Access Compliance Report Public Rights-of-Way (Curb Ramps)

Main Street: N/A Cross Street: ANTONIO_PKWY Location: N

ADA ID: RPAT220208123617 Ramp Type: Type 1 - Perpendicular Diagonal Initial Pass/Fail: Fail Overall Compliance: No Severity Score: 2

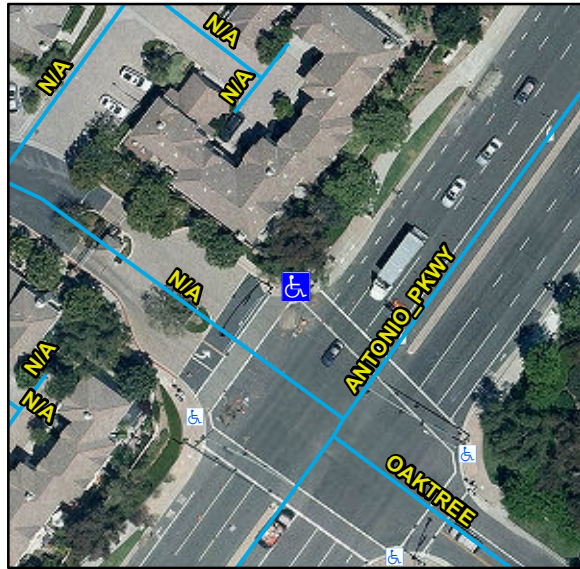
Compliance	Description	Data	Compliance	Description	Data
N/A	Ramp Length (in)	84	N/A	Flare Type LT	
Yes	Ramp Width (in)	60			N/A
Yes	Ramp Run Slope (%)	7.33	N/A	Flare Slope LT (%)	N/A
No	Ramp Cross Slope (%)	2.8	N/A	Flare Traversable LT	N/A
N/A	Landing Present	N/A	N/A	Flare Type RT	
N/A	Landing Length (in)	N/A			N/A
N/A	Landing Width (in)	N/A	N/A	Flare Slope RT (%)	N/A
N/A	Landing Run Slope (%)	N/A	N/A	Flare Traversable RT	N/A
N/A	Landing Cross Slope (%)	N/A	N/A	DWS Provided	N/A
N/A	Landing Movement Obstructed?	N/A	N/A	DWS Contrast	N/A
	Landing Movement Type	N/A	N/A	DWS Length (in)	N/A
N/A	Landing Shared	N/A	N/A	DWS Full Width	N/A
N/A	Clear Space	Yes	N/A	DWS Offset Left (in)	N/A
N/A	Clear Space To Crosswalk (in)	48	N/A	DWS Offset Right (in)	N/A
N/A	Marked Crosswalk 1	Yes	N/A	Marked Crosswalk 2	Yes
	Crossing 1 Direction	SW		Crossing 2 Direction	SE
	Marked Crosswalk 1 Width (in)	120		Marked Crosswalk 2 Width (in)	120

N/A	Ramp Inside Crosswalk 1	Yes	Yes	Ramp Inside Crosswalk 2	Yes
	Crossing 1 Slope (%)	2.5		Crossing 2 Slope (%)	1.1
	Crossing 1 Cross Slope (%)	2.68		Crossing 2 Cross Slope (%)	1.99
N/A	Gutter Ponding	N/A	N/A	Curb Slope	0.2
No	Gutter Lip Height (in)	0.28		Road Run Slope (%)	1.47
N/A	Gutter Run Slope (%)	N/A		Road Cross Slope (%)	0.4
N/A	Gutter Cross Slope (%)	N/A			
Yes	Overall Surface Condition: Acceptable		No	Perp Joint Present	No
	Cross Gutter Present?	No		Spandrel Present?	No
	Replace Cross Gutter?	N/A		Replace Spandrel?	N/A

Remove & Replace Curb Ramp With Two New Directional Ramps or Equivalent. Grind Gutter Lip.
